Access Compliance Report

Public Rights-of-Way

(Curb Ramps)

Intersection ID: 10040592	Main Street: W_ARROWWOOD_RD	Cross Street: N/A	Location: NW
ADA ID: 5B015FC22F10	Ramp Type: Perp	Initial Pass/Fail: Pass	Overall Compliance: No
Severity Score: 7.5			
Codes/Mitigation Info/Possible Solution		Field Measurements/Component Compliance

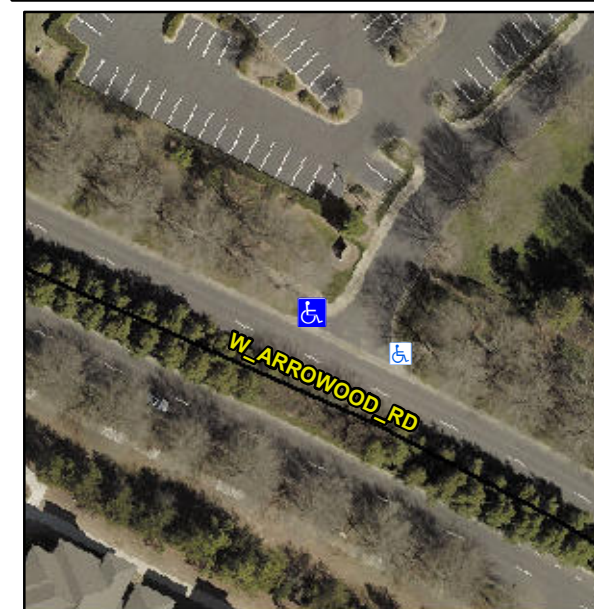
**Remove & Replace Entire Ramp.
Remove & Replace Gutter.**

**Not Found, R304.2.3, R305.2,
R304.5.4**
